Work Order ID 87297

Item ID: D412-664-203

Item Name: Crosstube Aft

DRAWING NO. D412-664-243	TITLE CROSSTUBE ASSEMBLY (412 HI AFT)	REV. E	DART AEROSPACE LTD ENGINEERING ORDER		D.E.O. NO. D412-664-243-E-1	SHEET NO. SHEET 1 OF 2	SCALE NTS	
DRAWN	CHECKED	MFG. APPR.	APPROVED	DE APPR.				
DATE 11.03.31	DATE 11/03.31	DATE 11.03.31	DATE 11/03.31	DATE 11.03.31

D212-664-243
ASSEMBLY DETAIL

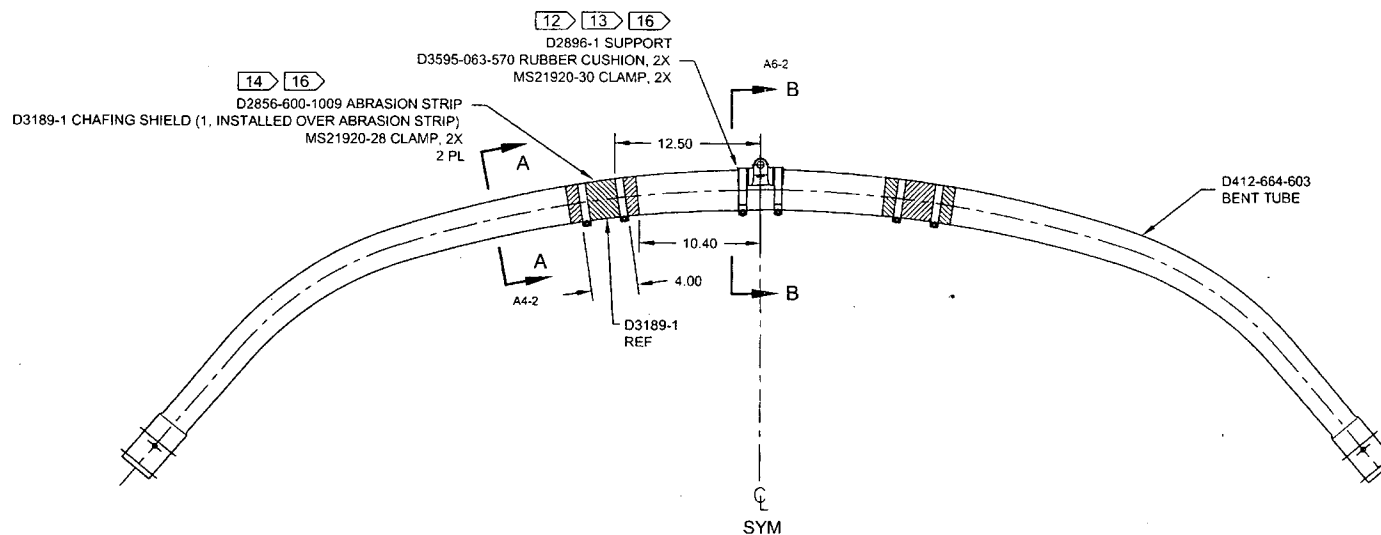
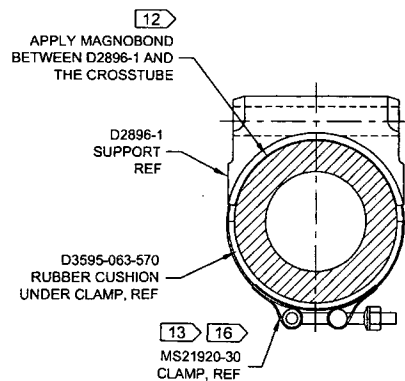
REMOVED ABRASION STRIP IN FAVOR OF A THIN LAYER OF PROSEAL 890.

NOTES 2 AND 14, SHEET 1 ARE AMENDED AS FOLLOWS:

- 2) FINISH: CHEMICAL CONVERSION COAT PER DART QSI 005 4.1
PRIME INSIDE AND OUTSIDE PER DART QSI 005 4.2
MASK UNDERSIDE OF CROSSTUBE AS SHOWN (HATCHED AREA)
PAINT OUTSIDE PER DART QSI 005 4.2
AFTER PAINTING, APPLY CLEAR COAT ON HATCHED AREA
- 14) APPLY A THIN COAT OF PROSEAL 890 ON INSIDE CONCAVE SURFACE OF D3189-1
CHAFING SHIELD AND LET CURE PER MANUFACTURER'S INSTRUCTIONS. INSTALL
PROSEALED D3189-1 CHAFING SHIELD ONTO CROSSTUBE BY APPLYING A THIN COAT OF
PROSEAL 890 ONTO CROSSTUBE. BE SURE TO ELIMINATE ANY AIR GAPS.

D3189-1 CHAFING SHIELD (1, INSTALLED OVER PROSEAL 890).
MS21920-28 CLAMP, 2X
2 PL

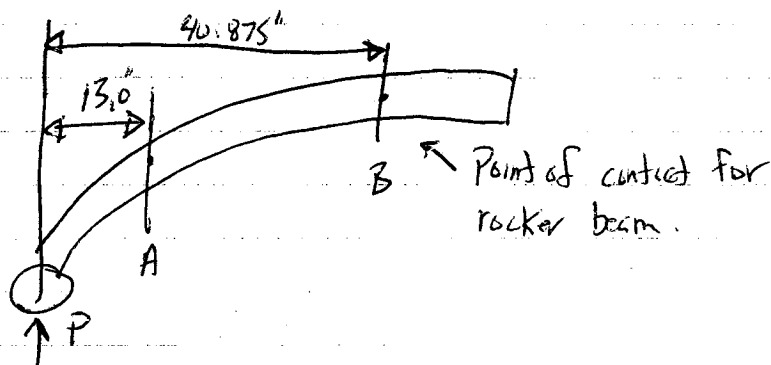
REPLACE MAGNOBOND WITH 3M DP460 SCOTCH-WELD EPOXY ADHESIVE

NOTE 12 & 16, SHEET 1 IS AMENDED AS FOLLOWS:

- 12) INSTALL D2896-1 CENTER SUPPORT USING A 0.04" TO 0.07" THICK LAYER OF SCOTCH-WELD DP460 PER QSI 015. LET CURE FOR 24 HOURS AFTER INSTALLATION AND PRIOR TO PACKAGING.
- 16) TORQUE CLAMPS 80 TO 100 IN-LB. ENSURE AT LEAST 1.5 THREADS SHOWING IN SAFETY AND THAT NUT HAS NOT BOTTOMED-OUT AFTER TORQUING. **PRIOR TO PACKAGING, RE-CHECK TORQUE ON CLAMPS AFTER ADHESIVE HAS CURED FOR 24 HOURS.**
